**PROJECT SPECIFIC PLAN FOR
AREA 9, PHASE III OUTFALL DITCH
PREDESIGN INVESTIGATION
(SUPPLEMENT TO 20300-PSP-0011)**

**FERNALD CLOSURE PROJECT
FERNALD, OHIO**

**21140-PSP-0002
Revision 1
FINAL**

APPENDIX C**AREA 9, PHASE III PREDESIGN VARIANCES**

FIGURE 1. 21140-PSA-0002-01

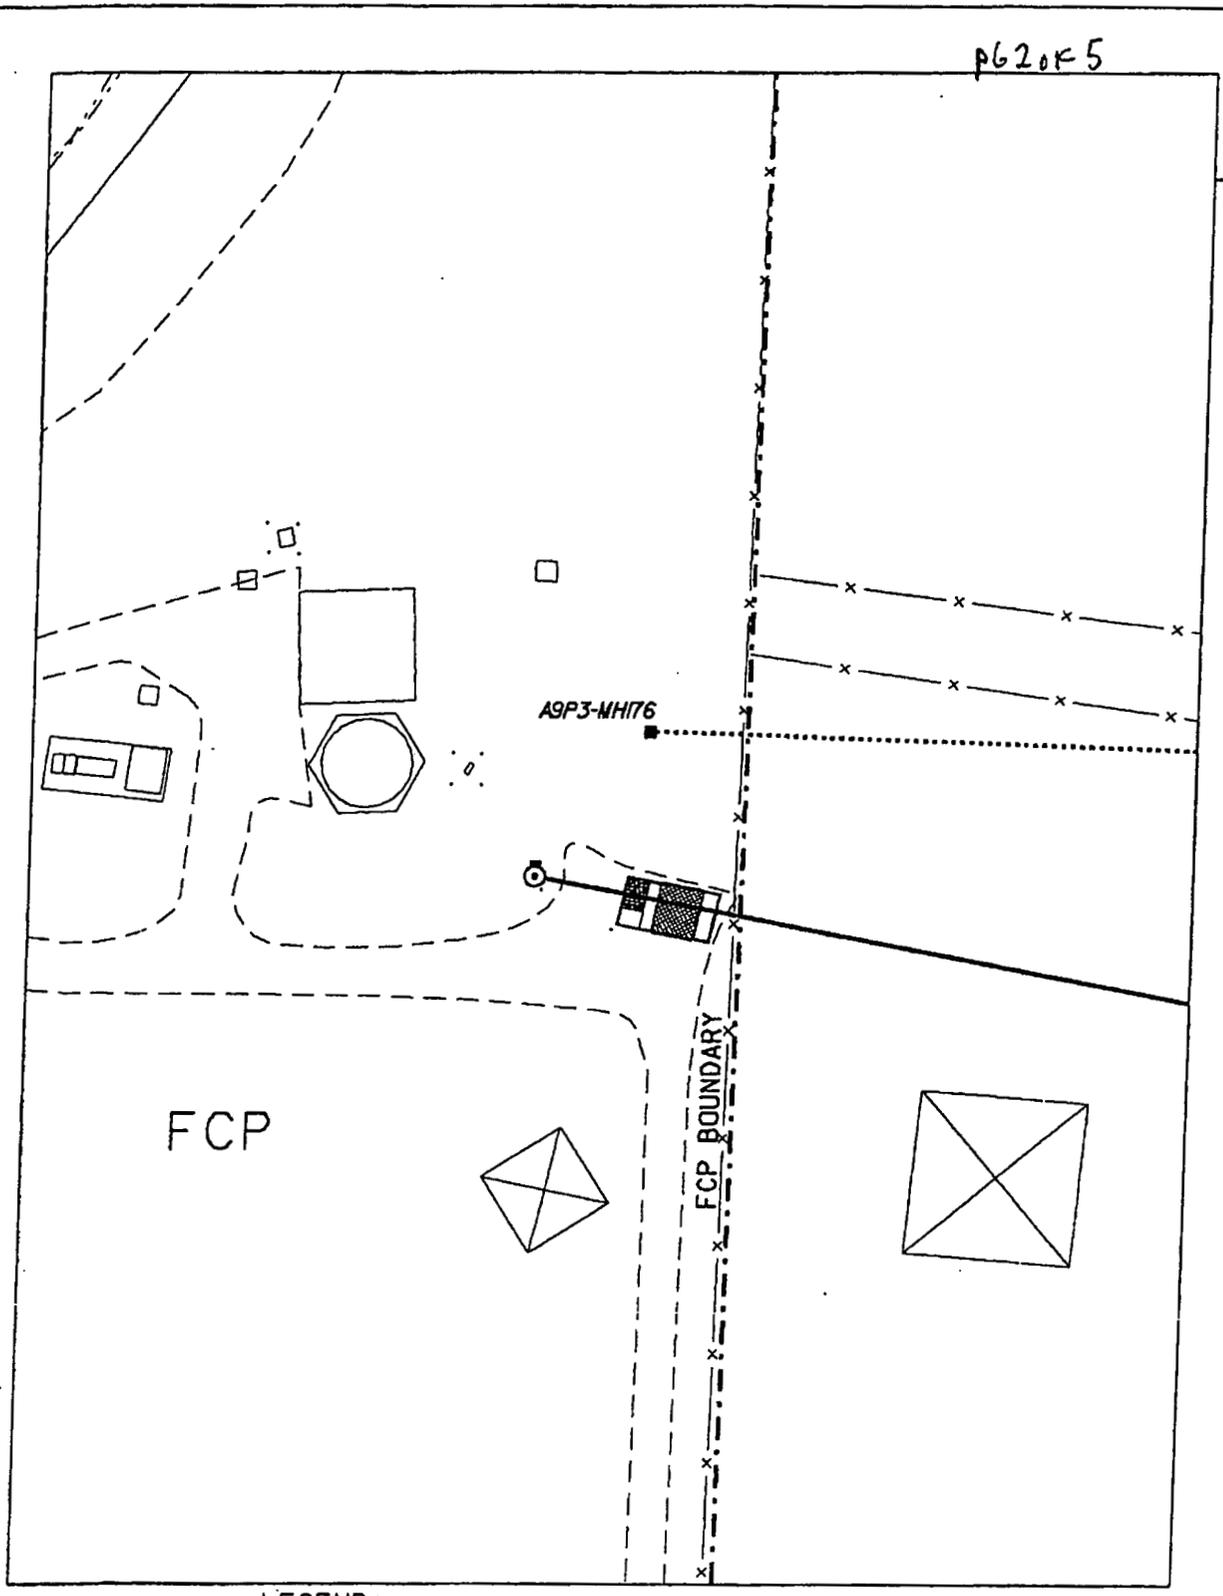
This Variance/Field Change Notice (V/FCN) documents the addition of MH-176 to the list of manholes to be sampled in Area 9, Phase III. Additionally, the original boring ID A9P3-MH180-17 and its associated location and sampling information listed in Appendix B, should be removed from the appendix. The original boring ID A9P3-MH180-18 and its associated sample ID will be changed to A9P3-MH180-17. These two changes are reflected in the revised Appendix B (attached).

MH-176 has been added to collect additional analytical data from within the abandoned outfall line. The original boring A9P3-MH180-17 was removed from the list of locations to be sampled because it is located on private property, which the FCP does not have an access agreement with.

FIGURE 1.

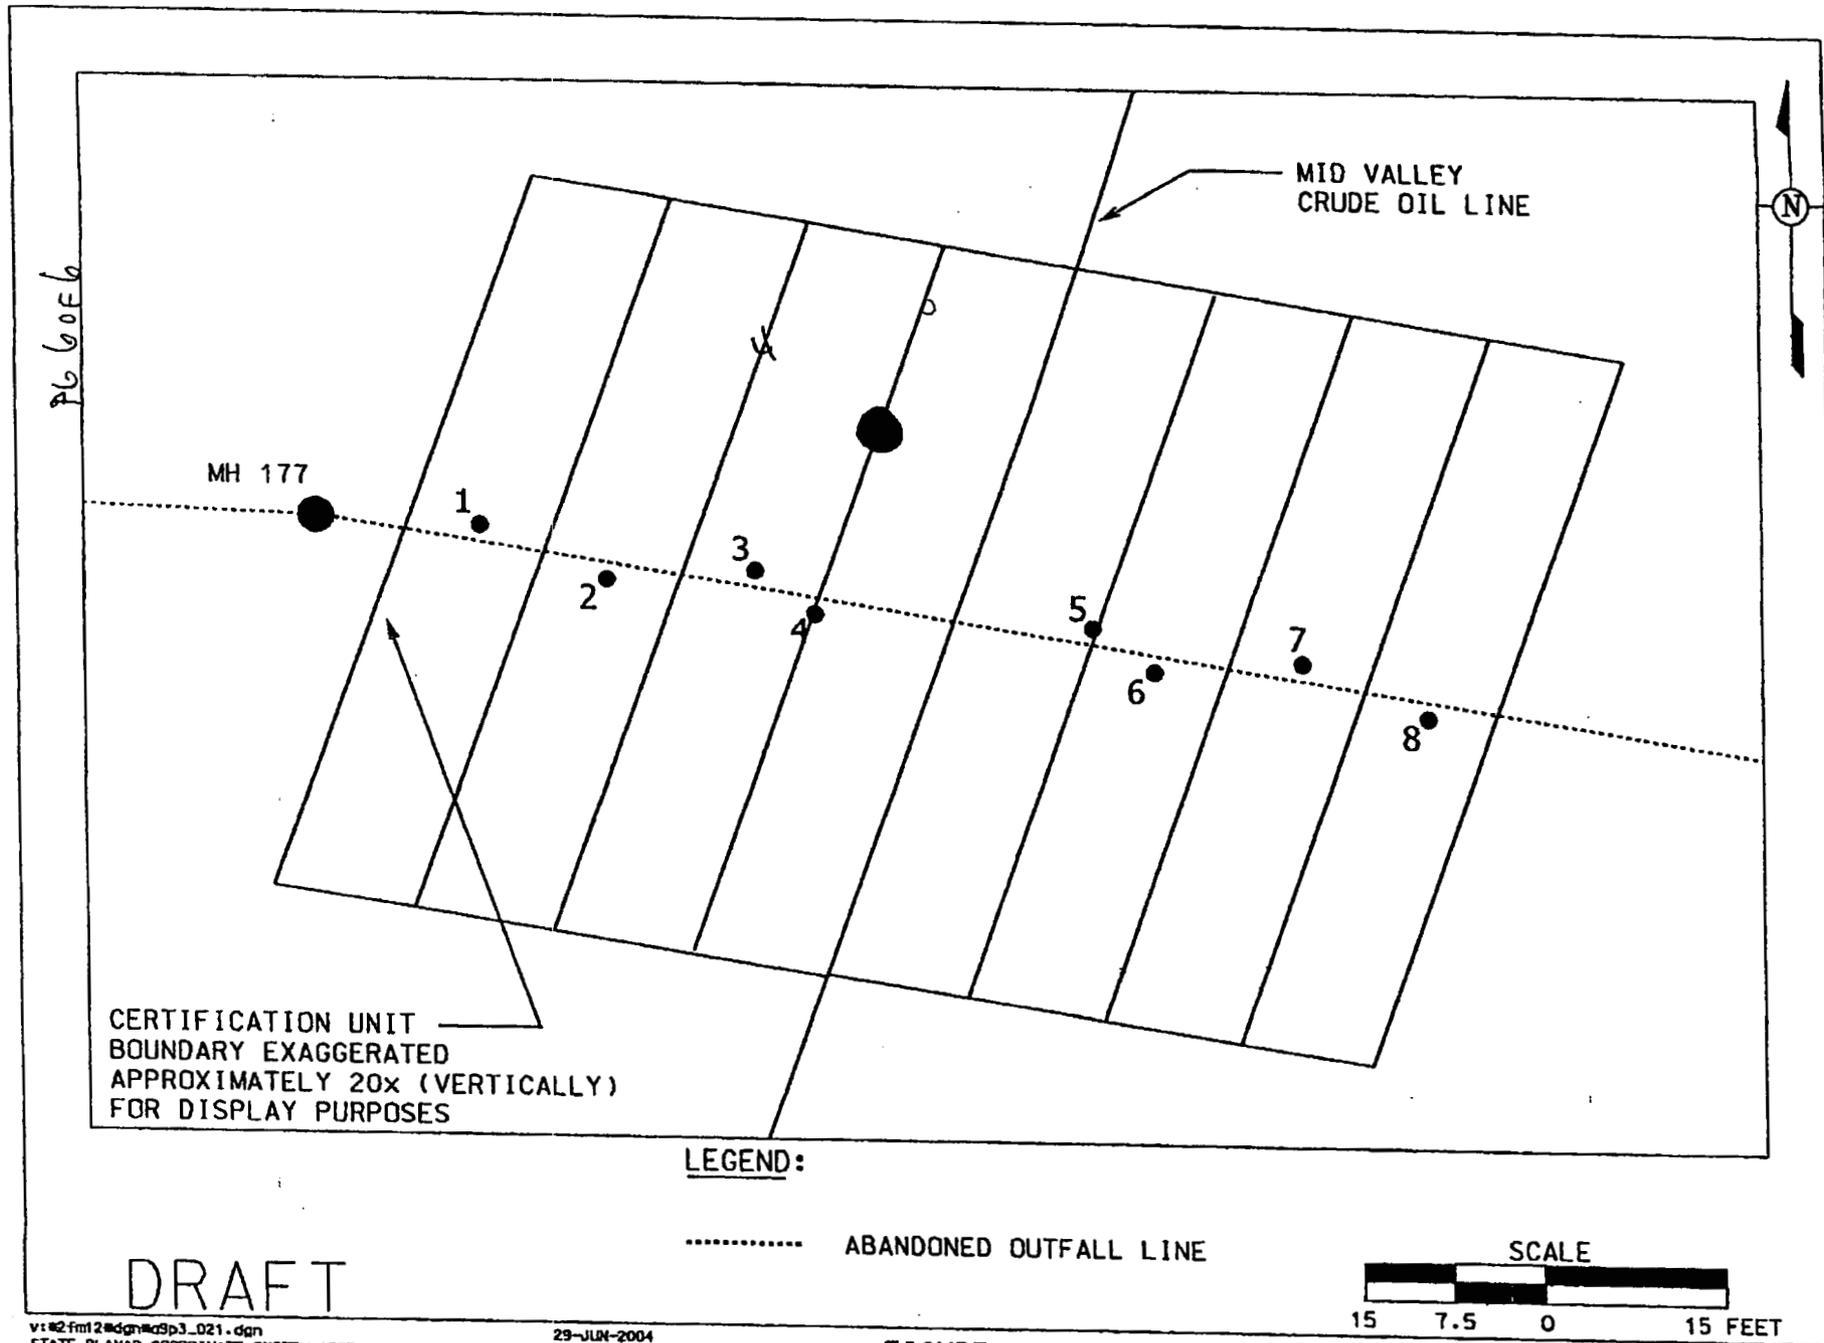
This Variance/Field Change Notice (V/FCN) documents the collection of additional samples from the 6 previously sampled locations in the area of MH180. The locations in this area will have a sampling interval from soil surface to 0.5 feet below surface and will be analyzed for the list of constituents found in Attachment 1.

FIGURE 1.

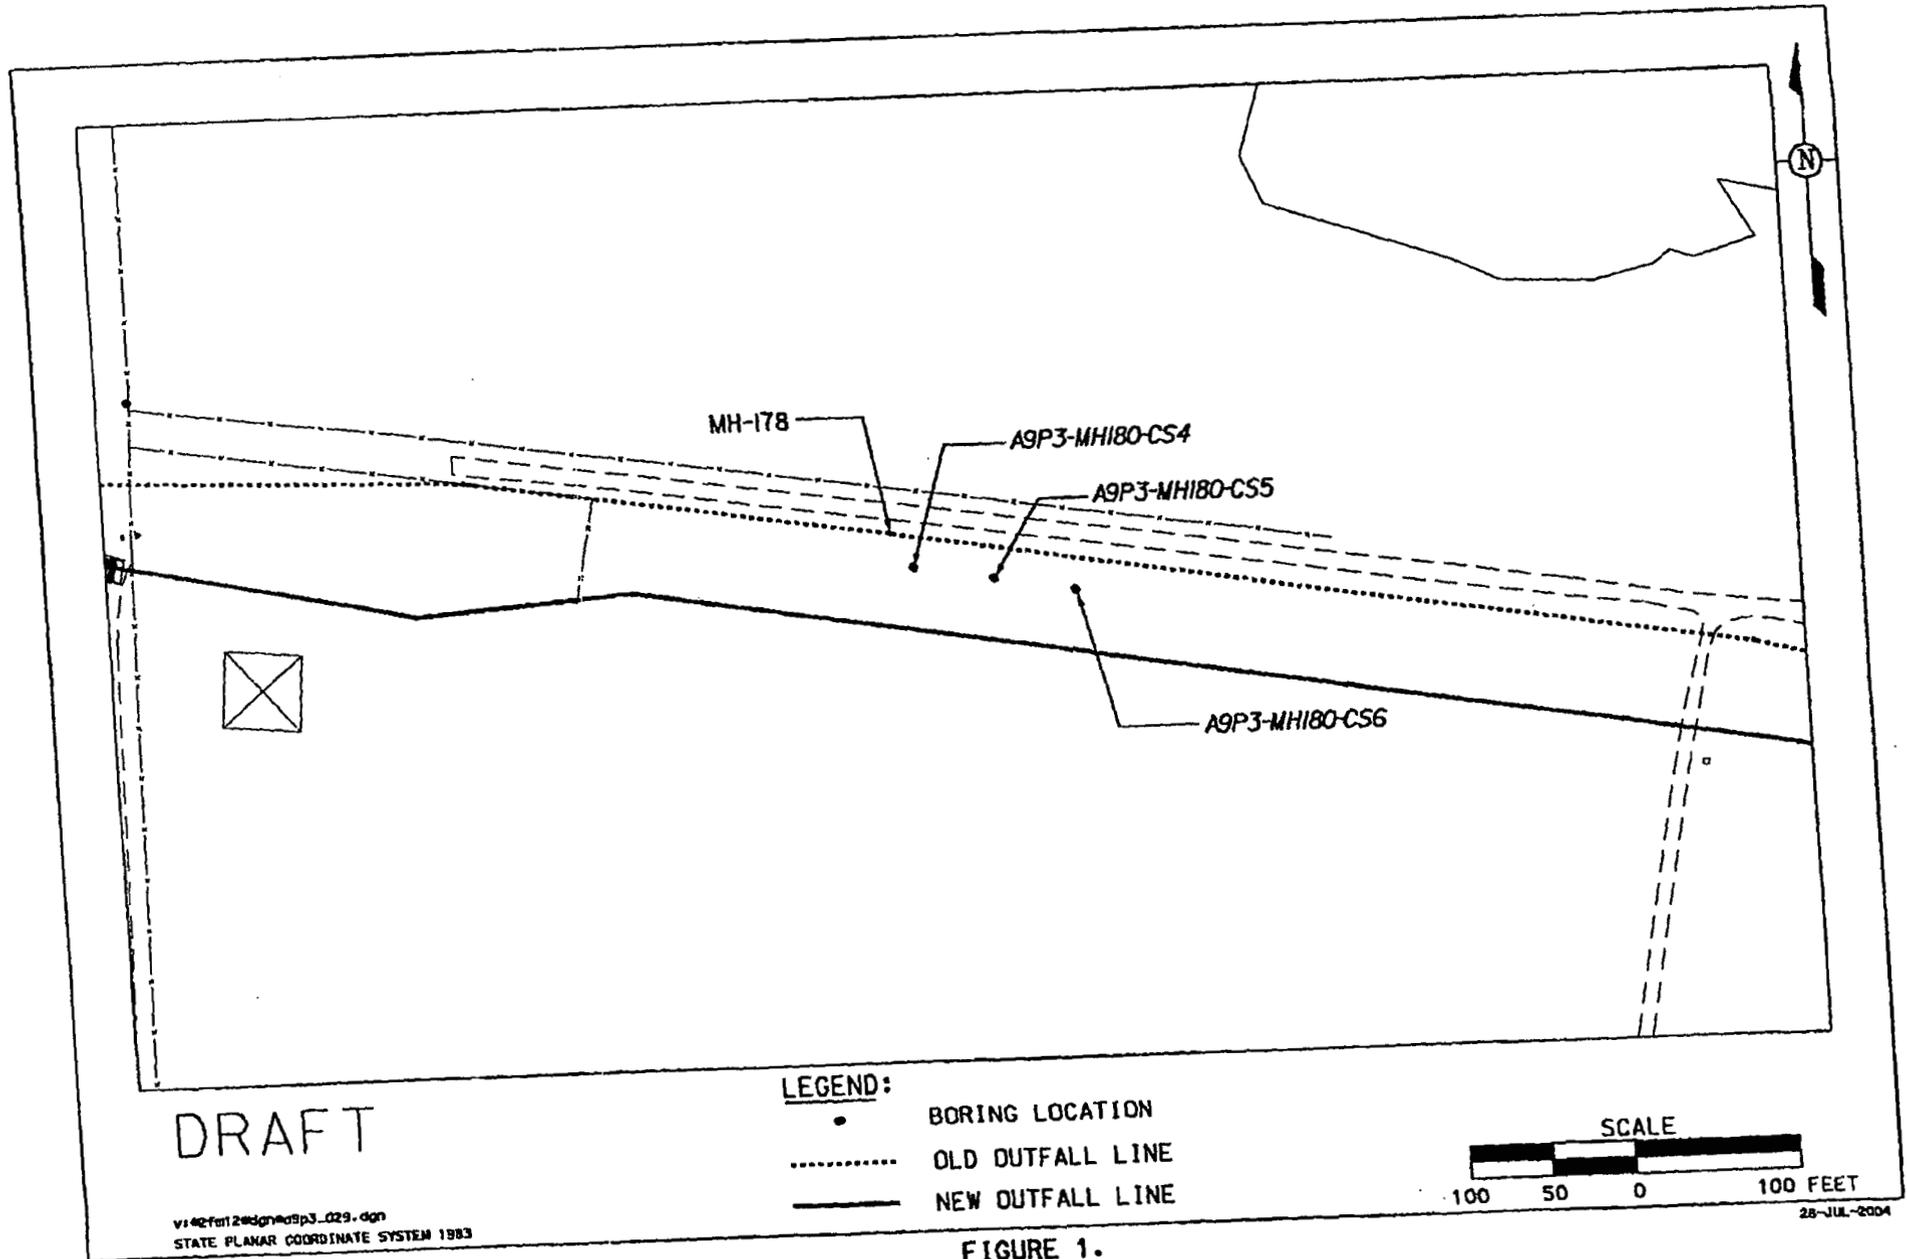
This Variance/Field Change Notice (V/FCN) documents the collection of additional samples from three locations to the west of MH180. The locations in this area will have a sampling interval from soil surface to 0.5 feet below surface and will be analyzed for boron and silver.

FIGURE 1.

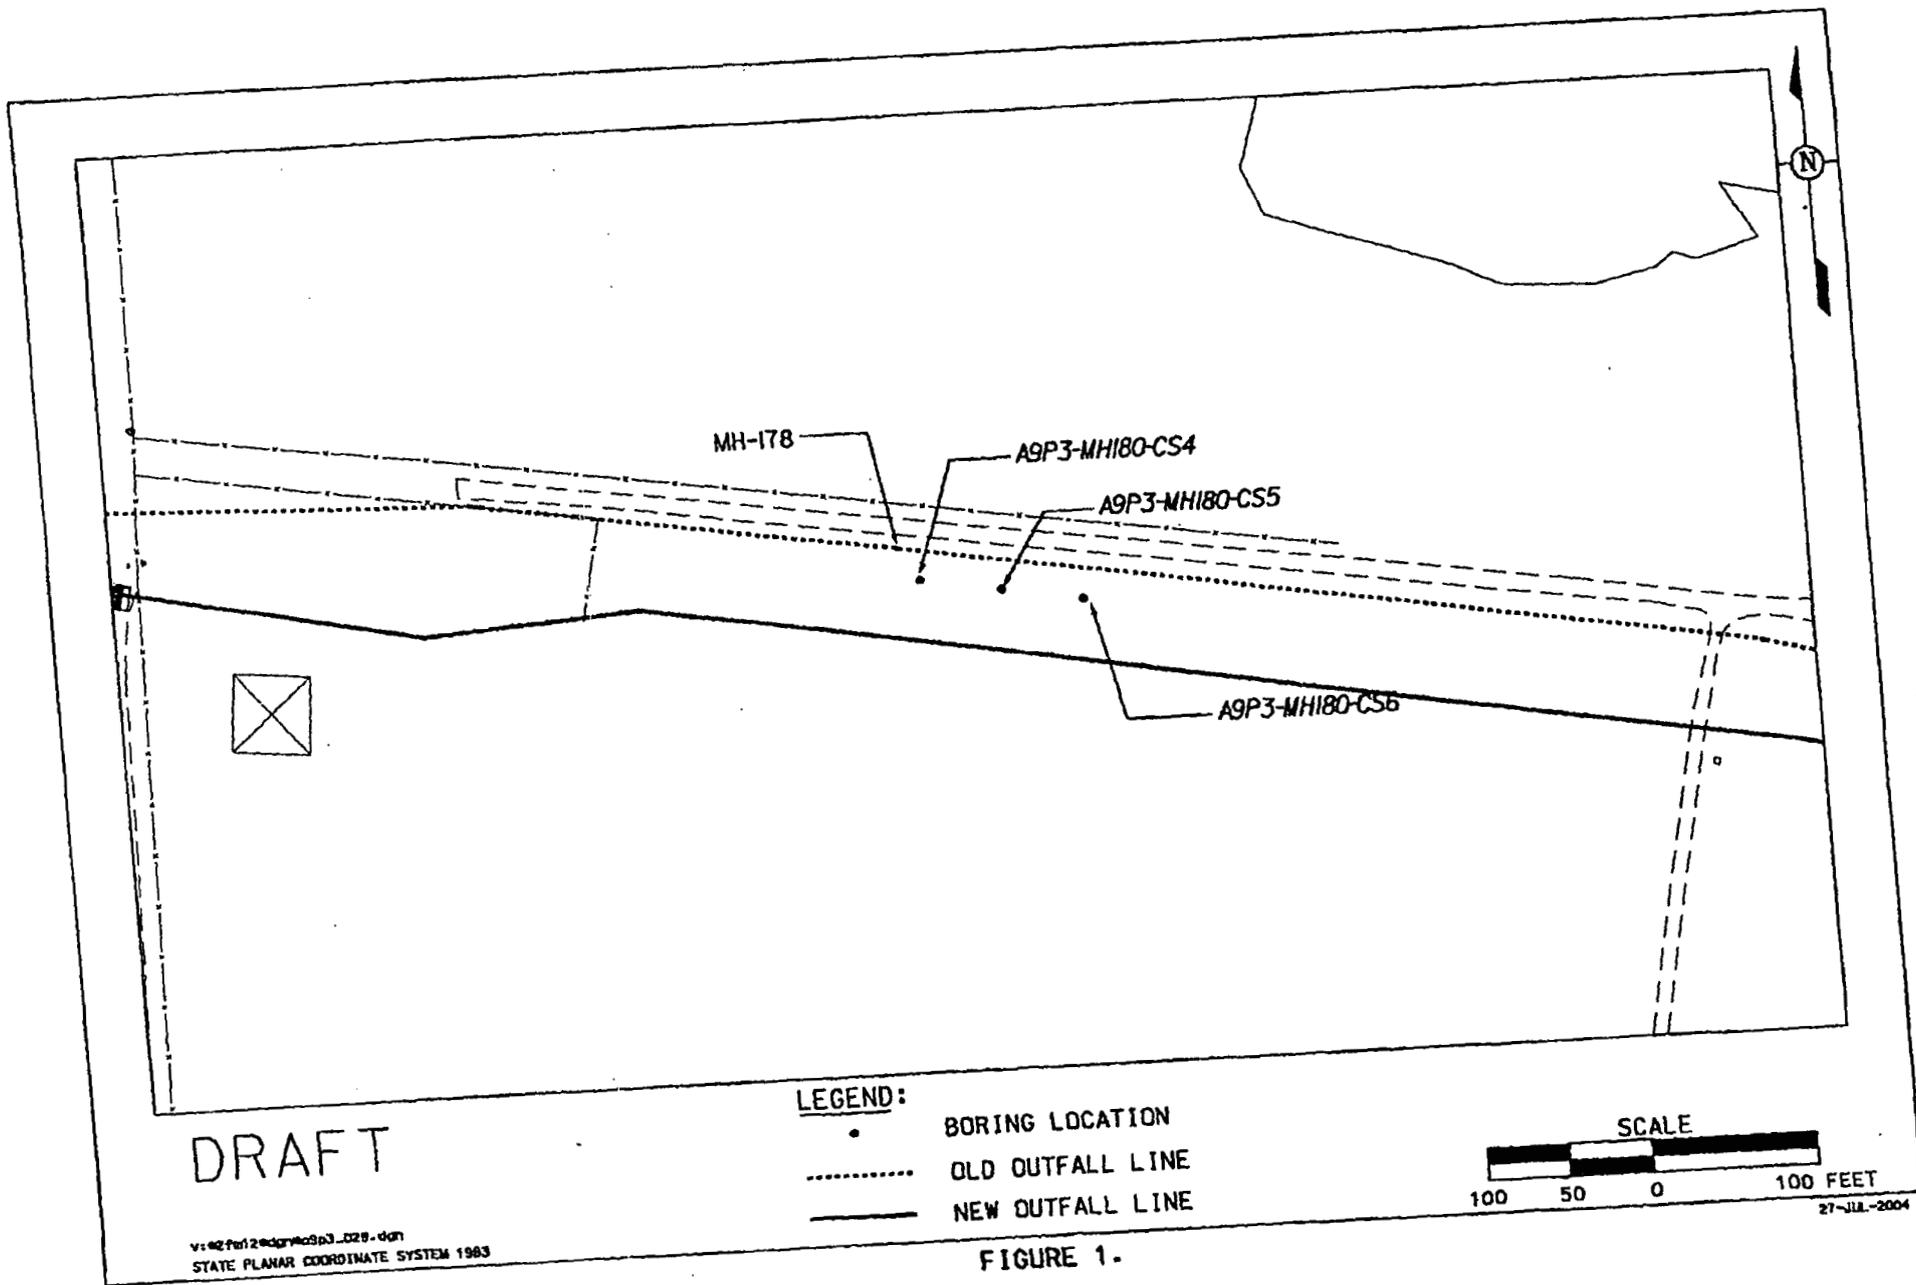
This Variance/Field Change Notice (V/FCN) documents the collection samples from nine additional locations near MH178 and MH 180. The locations should be placed as follows:

- Three of the locations will be field located by the field sampling lead and are to the east of MH178 along the southern fence line in the previously plowed area. There should be approximately 50 feet between each location. See Figure 1.
- Three locations (to be surveyed in) are to the west of MH180 and should have approximately 25 feet between locations. The first western location should be placed approximately 25 feet to the west of MH180 with the second and third continuing west. See Figure 2.
- The final three locations (to be surveyed in) are to the east of MH180. The first location should be placed approximately 125 feet to the east of MH180 and there should be 25 feet between each location. See Figure 2.
